AMENDMENT OF SOLICITATION/MODIFICATION OF CONTRACT

25-0009, Repair BEQ FC555
Amendment 0003, Answer Requests for Information

REPAIR BEQ FC555

Dg. GEJ-1.1

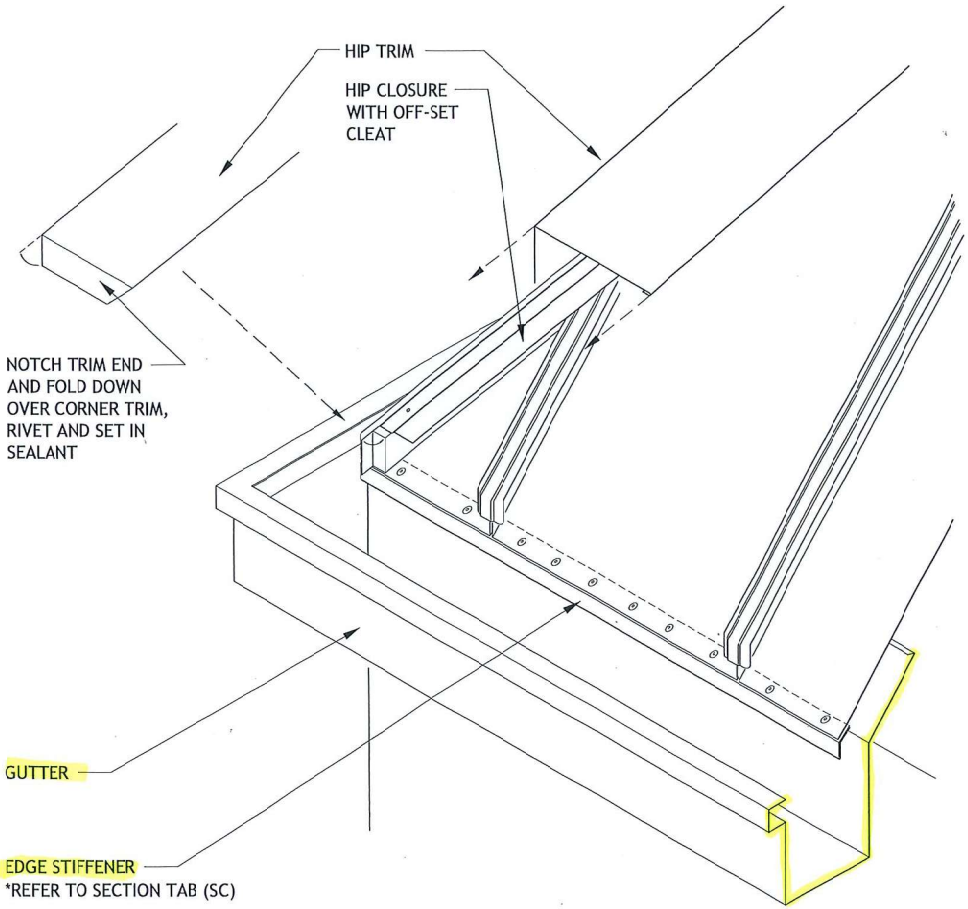
4. QUESTION: Demolition Note 9 on Drawing AD201 states "Demolish Existing Gutters and Downspouts". The existing Standing Seam Metal Roof is the Garland 2-3/8" high seam at 16"o.c., mechanically seamed "T" seam with concealed one piece clips. The Gutters on a Garland Roof extend up the fascia and across the roof plane underneath the ends of the Standing Seam roof panels. (See attached Gutter Details). The Gutters are fastened with screws up the roof slope under the panels approximately 7 inches from the ends of the roof panels. To remove the Gutters to install new Gutters, the roof panels must be removed off of the entire roof. Removal of the roof panels and the requirement to store and reinstall the same existing roof panels will most likely cause some damage to panels requiring new panels and new Seam Caps over the entire roof. Due to the extent of panel demo and reinstallation, and to maintain Garlands 30 year No Dollar Limit Warranty, it is recommended to demo the existing roof panels, demo the existing gutters and install new gutters and 15 new Garland Roof Panels per spec section 07 61 15.00 20.

1) Demolition Note 9 on Drawing AD201 states "Demolish Existing Gutters and Downspouts". The existing Standing Seam Metal Roof is the Garland 2-3/8" high seam at 16" o.c., mechanically seamed "T" seam with concealed one piece clips. The Gutters on a Garland Roof extend up the fascia and across the roof plane underneath the ends of the Standing Seam roof panels. (See attached Gutter Details). The Gutters are fastened with screws up the roof slope under the panels approximately 7 inches from the ends of the roof panels. To remove the Gutters to install new Gutters, the roof panels must be removed off of the entire roof. Removal of the roof panels and the requirement to store and reinstall the same existing roof panels will most likely cause some damage to panels requiring new panels and new Seam Caps over the entire roof. Due to the extent of panel demo and reinstallation, and to maintain Garlands 30 year No Dollar Limit Warranty, it is recommended to demo the existing roof panels, demo the existing gutters and install new gutters and new Garland Roof Panels per spec section 07 61 15.00 20.

ANSWER: Provide proposal per project documents. Contractor to determine means and methods.

Curb - Typical
Refer to Supporting Details 1-5
(RA) ROOF APPLICATIONS

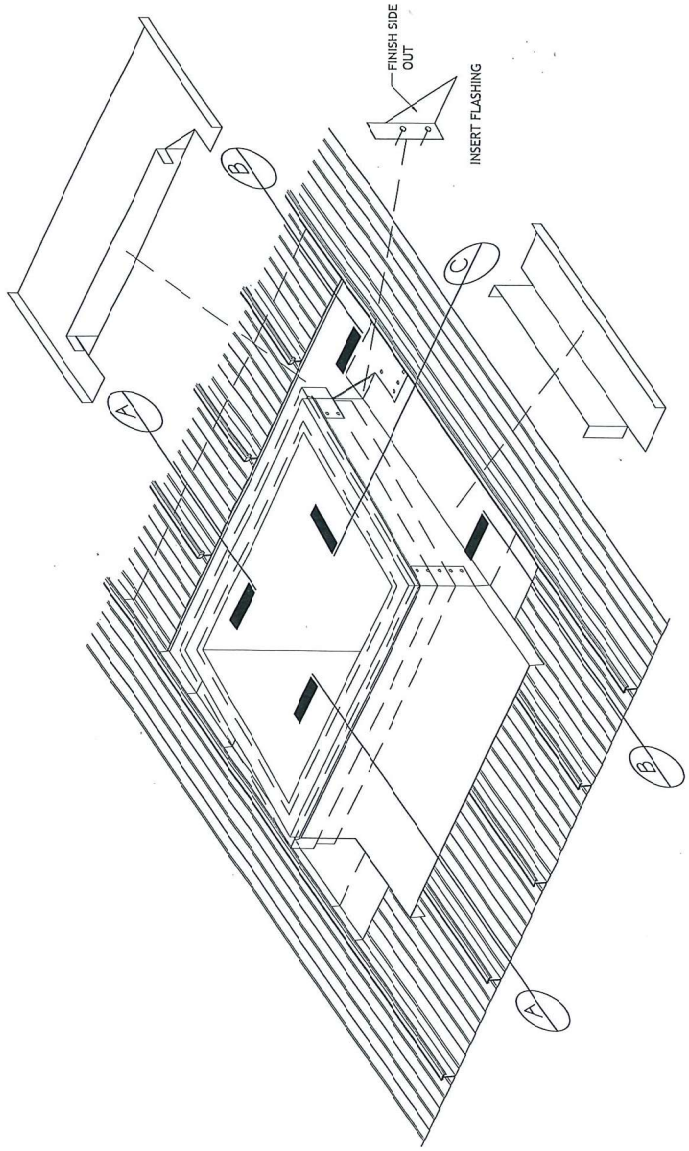
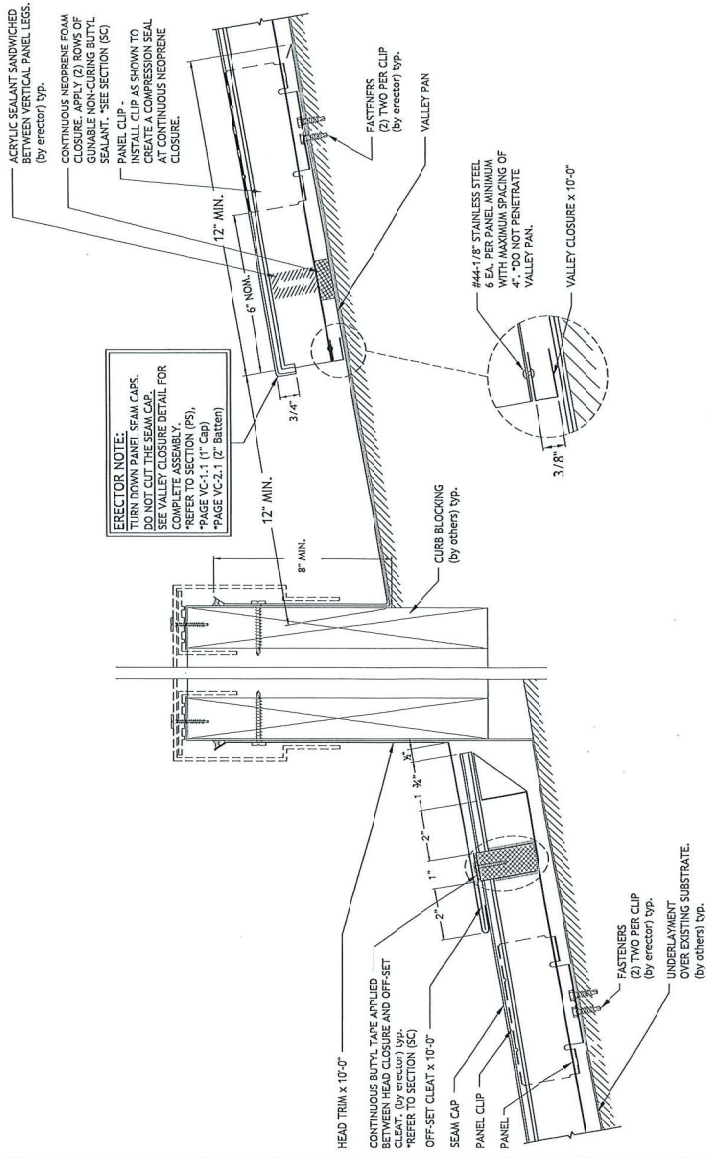
5. QUESTION: On drawing S-103 Detail B3 "Roof and Attic Plan", there are 3 Roof Access Hatches with plan notes stating "Remove Existing Roof Access Hatch and prepare opening for new hatch or infill-See ARCH." In order to remove the Roof Hatch and properly install a new Hatch with the flashings and trims required to waterproof the the penetration and maintain the roof warranty, roof panels must be removed to allow full access to all 4 sides. There are no notes indicating to remove roof panels. (See Garlands Flashing details and Highlighted Roof Plan for roof panels that will need to be removed). Due to the extent of panel demo and reinstallation, and to maintain Garlands 30 year No Dollar Limit Warranty, it is recommended to demo the existing roof panels and install new Garland Roof Panels per spec section 07 61 15.00 20. **SEE PAGES 4-12 FOR PROVIDED ATTACHMENT**

2) On drawing S-103 Detail B3 "Roof and Attic Plan", there are 3 Roof Access Hatches with plan notes stating "Remove Existing Roof Access Hatch and prepare opening for new hatch or infill-See ARCH." In order to remove the Roof Hatch and properly install a new Hatch with the flashings and trims required to waterproof the penetration and maintain the roof warranty, roof panels must be removed to allow full access to all 4 sides. There are no notes indicating to remove roof panels. (See Garlands Flashing details and Highlighted Roof Plan for roof panels that will need to be removed). Due to the extent of panel demo and reinstallation, and to maintain Garlands 30 year No Dollar Limit Warranty, it is recommended to demo the existing roof panels and install new Garland Roof Panels per spec section 07 61 15.00 20.

ANSWER: Provide proposal per project documents. Contractor to determine means and methods.

B3 ROOF AND ATTIC PLAN
SCALE: 3/32" = 1'-0"

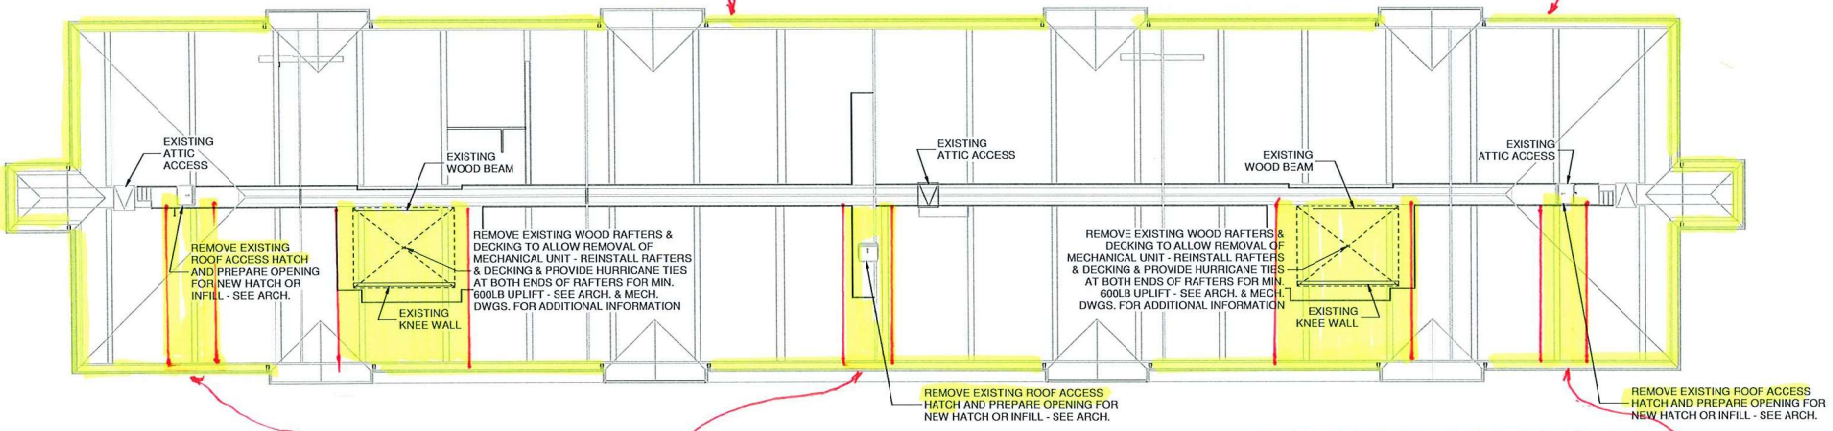
GUTTERS WILL REQUIRE THE REMOVAL OF ROOF PANELS - TYP. TO ALLOW REMOVAL AND INSTALLATION OF NEW GUTTERS

ROOF PANELS MUST BE REMOVED TO DEMO AND INSTALL NEW ROOF HATCHES
